CUSTOMER USE DRAWING

DWG. NO. B-9077060 SH 1 REV B

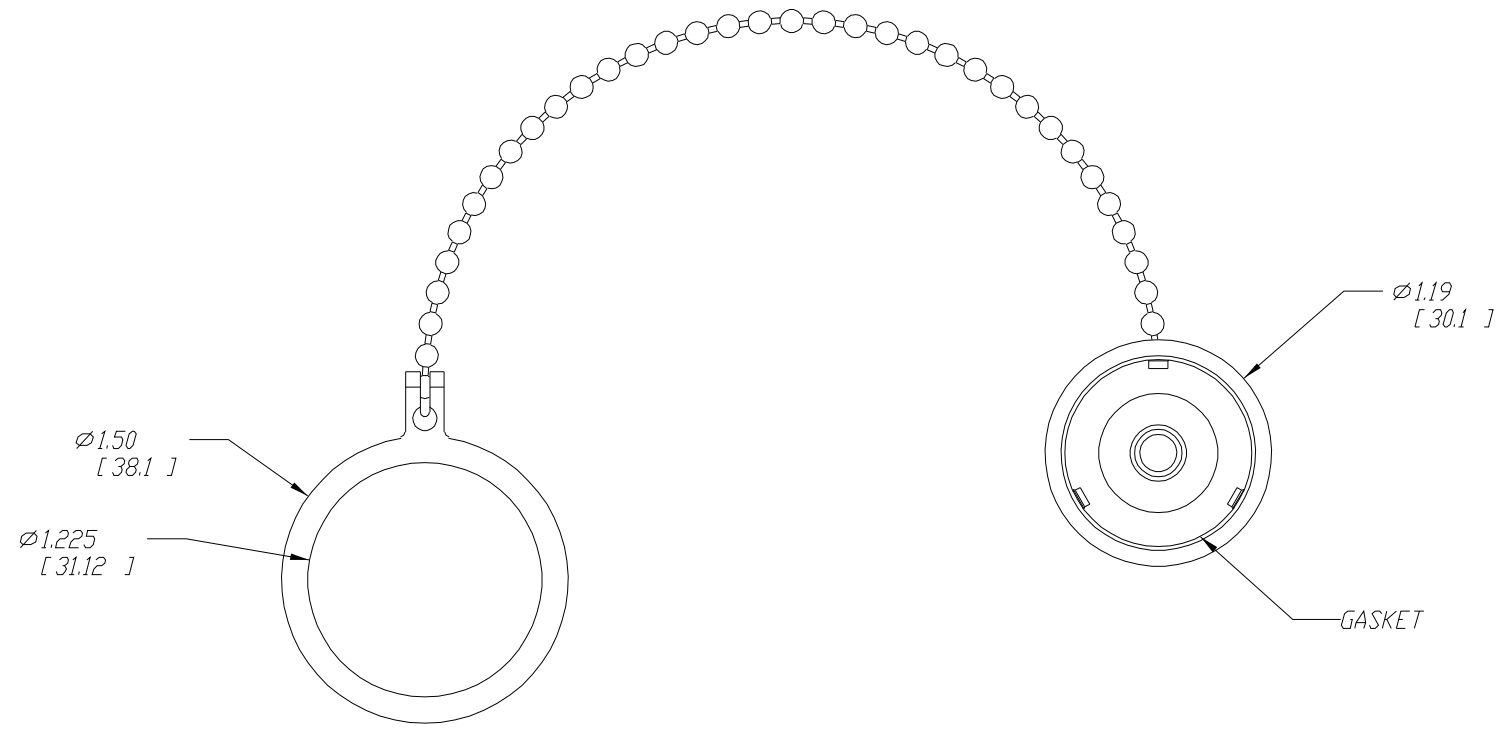
REV.	ECO NO.	REVISIONS	BY	DATE	APVD.
A	6954	NEW RELEASE	FWM	3/5/02	FWM 3/6/02
B	1241	B1: REMOVE HEX SHAPE FROM INNER CUTOUT / NOW ONLY 1.225 DIAMETER HOLE. B2: REMOVE SECONDARY WASHER	JOK	1/23/07	W.P. 1/23/07
